### DOOR COVER BOTTOM WITH ADD GASKET TO EVOID STEAM INSIDE THE DOOR ON APOLLO

This service instruction for assembling the door cover bottom with the additional gasket (spare part kit **561 83 15-26/0**), is valid for all Apollo Steamer from serial start **(2012)** until **3 10 20224 (2013)**.

Door cover bottom, original state (Code <b>387 92 24-21/4</b> )	Door cover bottom, modified with additional gasket (Code <b>561 83 15-26/0</b> )
 <p style="text-align: center;">HDC06117.JPG</p> <p>Fig. 1</p>	 <p style="text-align: center;">HDC06118.JPG</p> <p>Fig. 2</p>

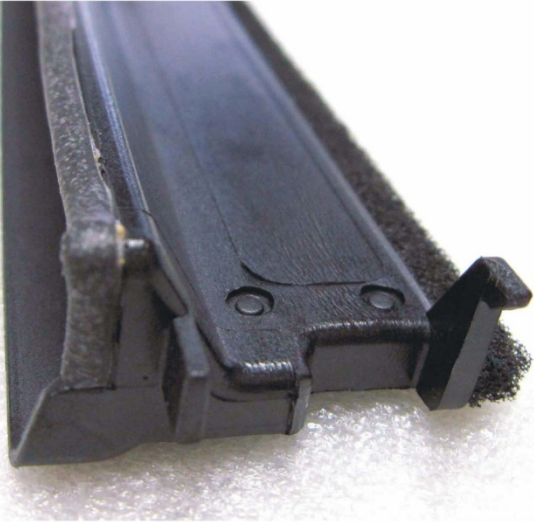
**PROBLEM :** Steam inside the door (between the glasses).

**REASON :** On the bottom part, the door is not tight.

**CAUSE :** Gap between inner glass door and door cover bottom.

1. Unhinge the door and open according guideline.
2. Change original door cover bottom against the new one with the additional gasket (see Fig. 1 and 2). Pay attention not to displace the gasket.
3. Carefully reassemble the door, mount the door in the oven and proceed with the functional test.
